# Addendum No. 3 March 26, 2025

Solicitation No. 230 – Request for Qualifications
Professional Engineering Services for a
Scotlandville Parkway Mobility Network Project
Submittal Deadline 11:00 a.m. CT on April 1, 2025
Recreation and Park Commission for the Parish of East Baton Rouge
BREC Planning & Engineering Department

# Exhibit C Topographic Survey Scope

# Topography for Bridge "B" (East of 70th Avenue)

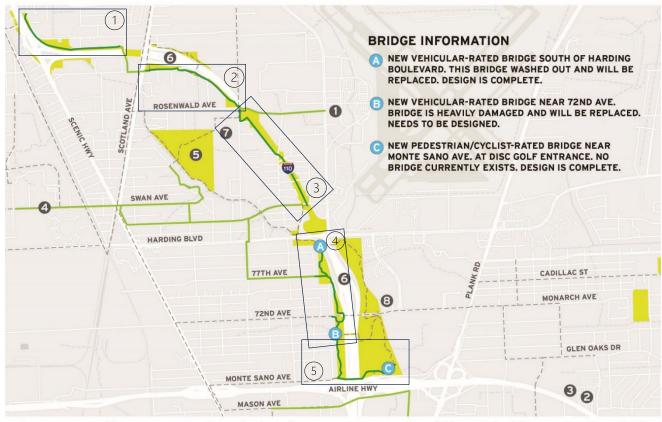
- Conduct a detailed topographic survey to develop demolition and construction plans for the proposed project site.
- Includes establishing horizontal and vertical control, locating existing bridge remnants, and surveying the topography of existing ground along the connecting trail and laterally along the ditch.
- Prepare a topographic map and digital terrain model to serve as a background for design purposes.

# Corridor to be surveyed

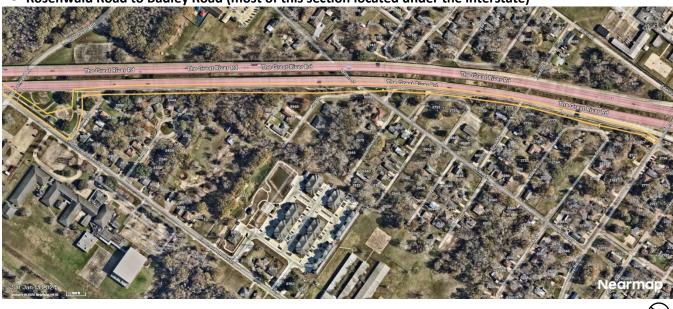
Note: survey extent to be within the yellow-lined corridor. Area subject to change at the discretion of BREC and the consultant
